Interactive comment on “Validation of ACE and OSIRIS ozone and NO₂ measurements using ground-based instruments at 80° N” by C. Adams et al.

C. Adams et al.

Received and published: 27 March 2012

Fig. 1.

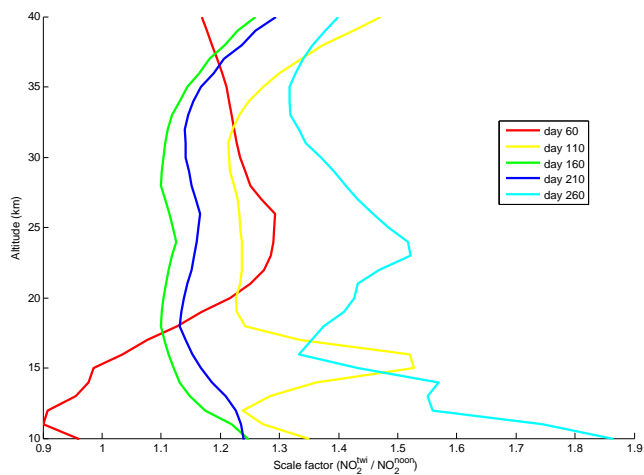
Page 536, 1st paragraph: Have the model results been degraded to the vertical resolution of the instrument with the worst vertical resolution? Probably not. This may be important for the GB profiles with poorer vertical resolution, and this aspect should be discussed in more detail.

No the model has not been degraded to the vertical resolution of the instruments. The figure below shows scale factors as a function of altitude for various days throughout a year. These were calculated with the photochemical model at 80°N, using climatological ozone and temperature for an evening twilight measurement. Twilight is defined at SZA 90° or the smallest available SZA during the summer months of 24-hour sunlight. The scale factor does not change much with altitude, particularly for 15-35 km, where the bulk of the NO₂ column is found. Therefore, we don't expect this to contribute a large error to our comparisons. We will add a note of this possible source of error to the text:

“The model profiles were not degraded to the resolution of the ground-based instruments prior to scale-factor calculations. The modeled ratio of twilight to noon NO₂ does not vary greatly with altitude for 15-35 km, where the bulk of the NO₂ column resides. Therefore, the error that this introduces is expected to be small.”
